UNITED STATES PATENT AND TRADEMARK OFFICE

| APPLICATION NO. | FILING DATE | FIRST NAMED INVENTOR | ATTORNEY DOCKET NO. | CONFIRMATION NO. |
|---|-------------|----------------------|---------------------|------------------|
| 10/621,865 | 07/17/2003 | Donald A. Becken | THI-304 | 1753 |

| Office Action Summary | Application No. 10/621,865 | Applicant(s) BECKEN | |

DETAILED ACTION

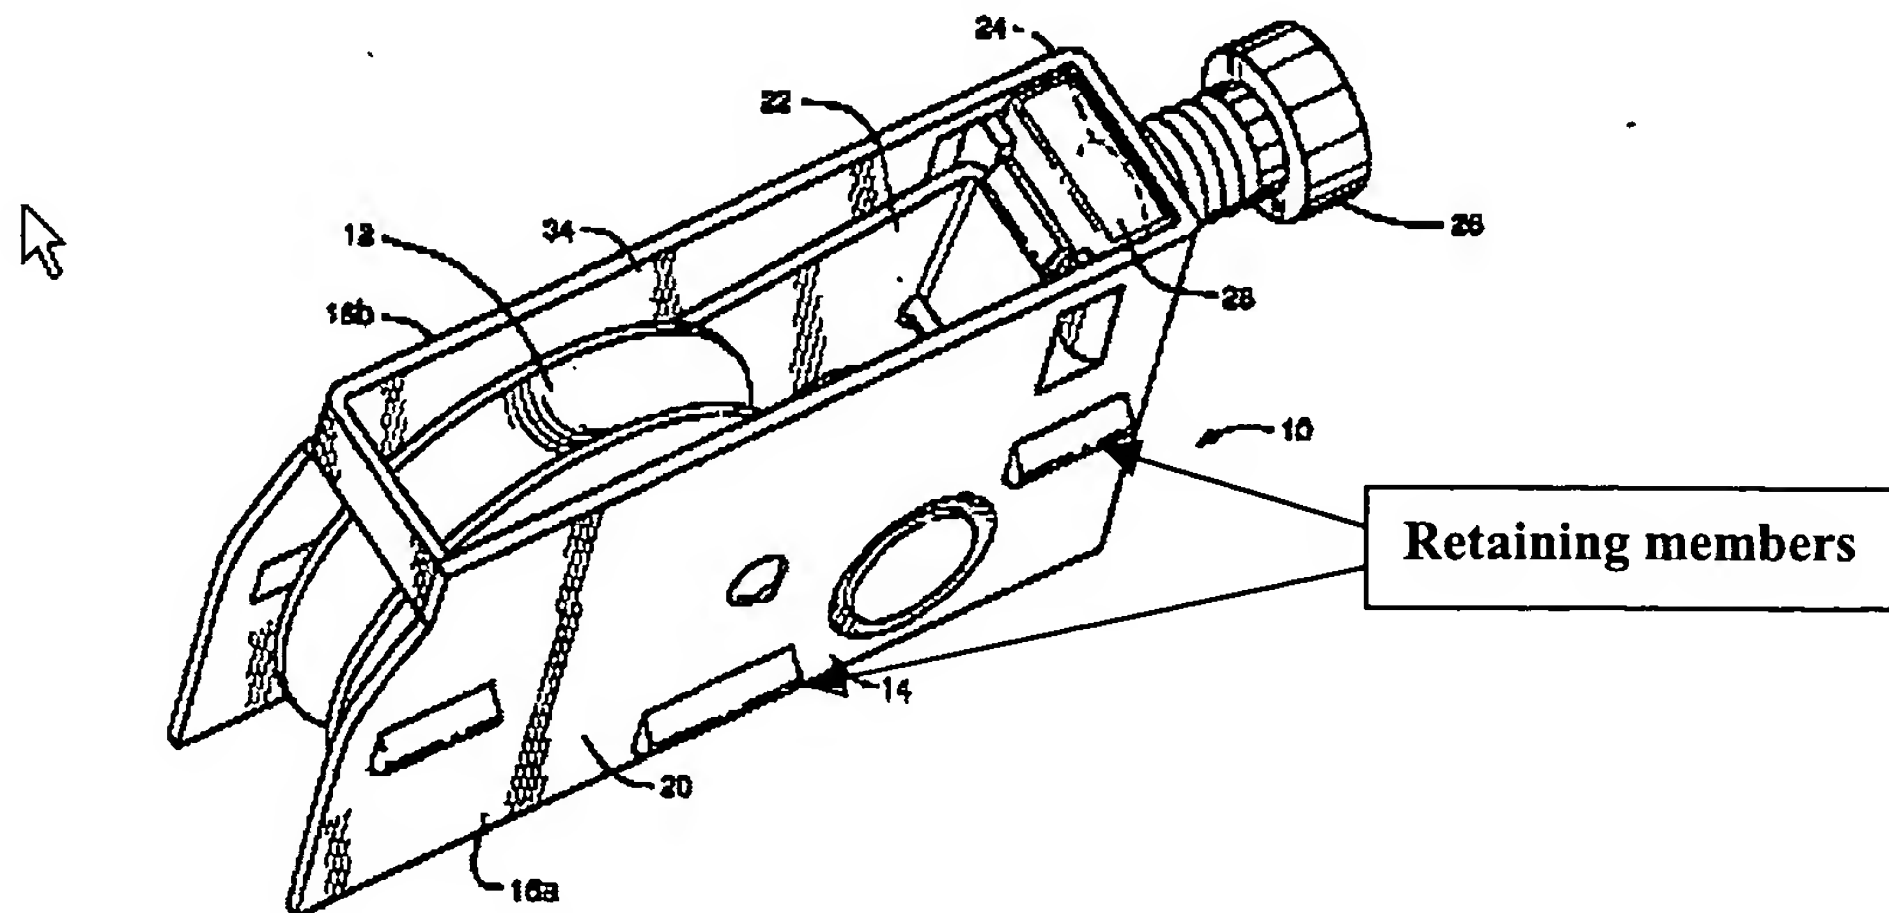
Marquardt, and Becken teach the general concept of retaining members, meeting the claimed limitations (Ezman: elements 27, 28; Marquardt: elements 32; and Becken: see the below image). These retaining members are for limiting movement of the housings and securing it within a frame, as conventional in the art. It would have been obvious at the time the invention was made for one skilled in the art to have included in the design of Anderson such a modification, as generally taught in each of Ezman, Marquardt, and Becken, for the purpose of providing alternative means for limiting movement of the housings and securing it within a frame.
